ski-doo®

2009 Technical Update Book

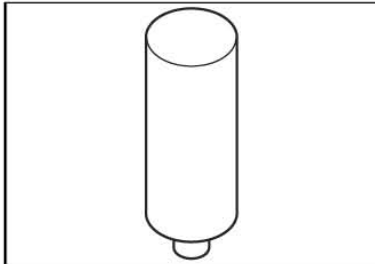
Rotary Valve Bearing Pusher
P/N 420 876 501 Recommended
717, 787 & 787 RFI engines

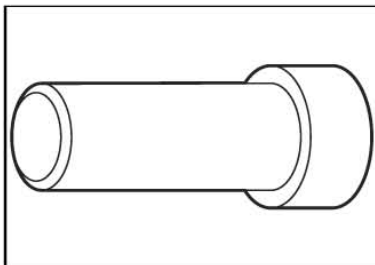
Crankshaft Protector
P/N 420 876 557 Recommended
717 / 787 RFI / 800R / 800 HO

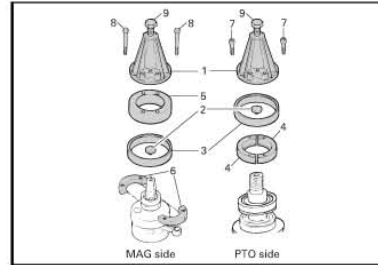
Flywheel puller
P/N 420 976 235 Recommended
247, 787, 787 RFI, 947 & 947 DI engines
Replacement bolt P/N 529 035 549.

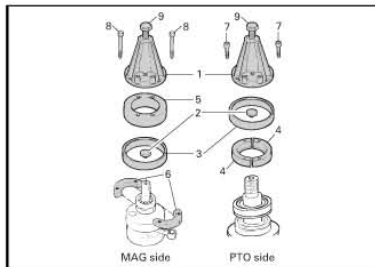
HALF RING PULLER
P/N 420 977 475 Recommended
717 / 787 RFI engines

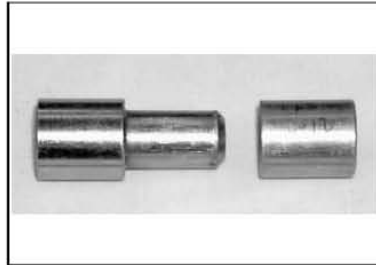
Sleeve kit 20 mm
P/N 529 035 542 **Mandatory**
717, 787 RFI, 600, 800HO
Used with 529035503

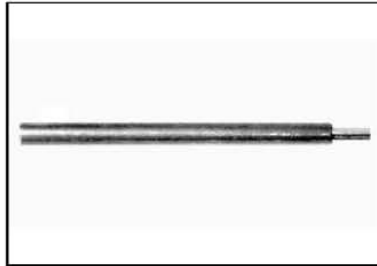
Fuel pressure gauge
P/N 529 035 591 Recommended
787 RFI, 793 SDI & 4-TEC engines
Replaced by 529 035 709. Spare plastic clip P/N 275500429
